TECHNICAL BULLETIN	
	February 1996 TB 1310
Mfg:	FORD
Model:	RANGER
Liter:	4.0L
V I N:	X
Year:	90-08

Revised Intake Manifold Gasket On
1992-94 Ford 4.0L Engines

Bulletin Diagram: Untitled Graphic #2139 for TB 01310

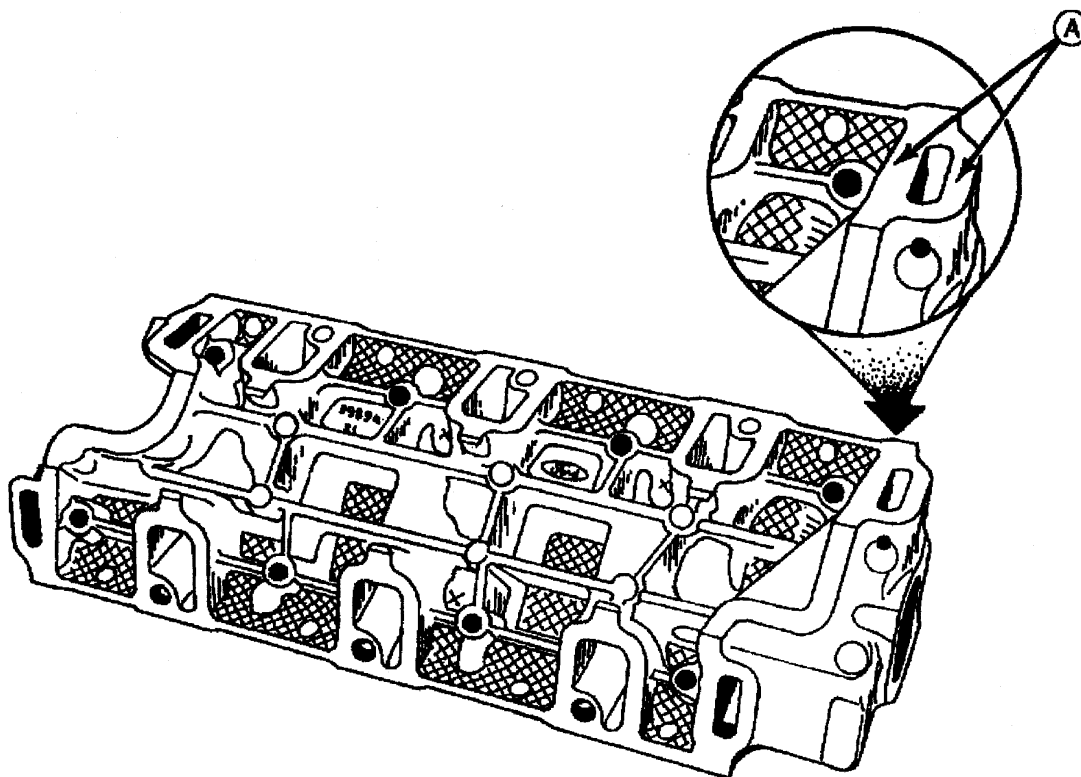
There are four possible areas where engine coolant may leak at the intake manifold cylinder head joint as shown in the illustration below. The intake manifold may also be pitted, corroded or eroded in these areas. If there is damage that should be repaired, building up the area through welding is an effective repair. If this is not possible, the manifold should be replaced.

AERA members have reported coolant loss through the intake manifold on 1992-94 Ford 4.0L engines. The Ford Motor Company now offers a revised carrier type intake manifold gasket, Part #F5TZ-9439-A, to reduce the possibility of a leak.

Ford suggests checking the torque of the cylinder head bolts at the time of intake manifold removal on engines with coolant loss. Ford also recommends replacing cylinder head gaskets if any head bolt does not have 59 ft.lbs. of torque.
